POINT BEACH NUCLEAR PLANT, UNIT NO. 1

AMENDMENT TO FACILITY OPERATING LICENSE

Amendment No. 71 License No. DPR-24

ATTACHMENT TO LICENSE AMENDMENTS

FIGURE 15.3.1-5

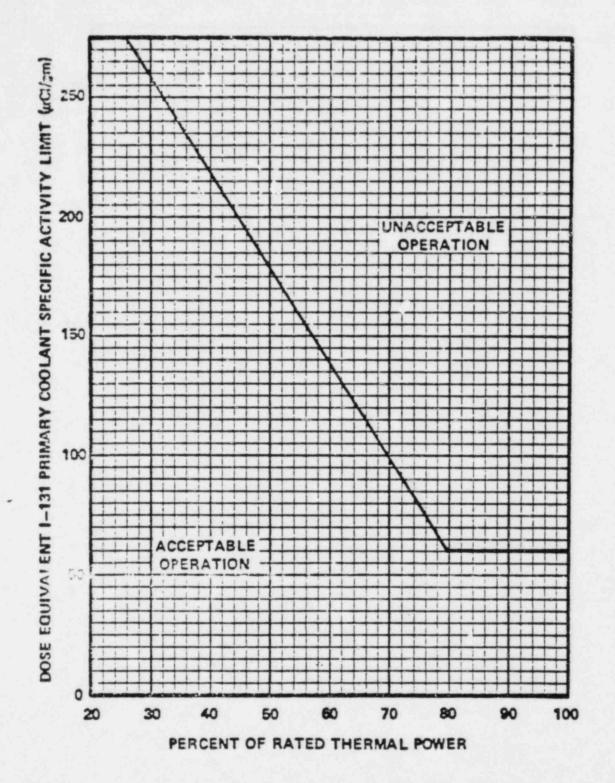
- 1. Less than or equal to 1.0 microcurie per gram Dose Equivalent I-131.
 - a. If the specific activity of the reactor coolant is greater than 1.0 microcuries per gram Dose Equivalent I-131 but within the allowable limit (below and to the left of the line) shown on Figure 15.3.1-5, operation may continue for up to 48 hours provided that the cumulative operating time under these circumstances does not exceed 800 hours in any consecutive 12-month period. Reactor Coolant Sampling shall be in accordance with Table 15.4.1-2. A Special Report shall be prepared in accordance with specification 15.6.9.3.F if cumulative operating time above exceeds 500 hours in any consecutive 6-month period.

- b. If the specific activity of the reactor coolant is greater than 1.0 microcuries per gram Dose Equivalent I-131 for more than 48 hours during one continuous time interval or exceeds the allowable limit (above and to the right of the line) shown on Figure 15.3.1-5, the reactor will be shut down and the average reactor coolant temperature will be less than 500°F within 6 hours.

Continued power operation for limited time periods with the reactor coolant's specific activity greater than 1.0 microcurie/gram Dose Equivalent I-131, but within the allowable limit shown on Figure 15.3.1-5, accommodates possible iodine spiking phenomenon which may occur following changes in thermal power. Operation with specific activity levels exceeding 1.0 microcurie/gram Dose Equivalent I-131 but within the limits shown on Figure 15.3.1-5 increase the 2-hour thyroid dose at the site boundary by a factor of up to 20 following a postulated steam generator tube rupture.
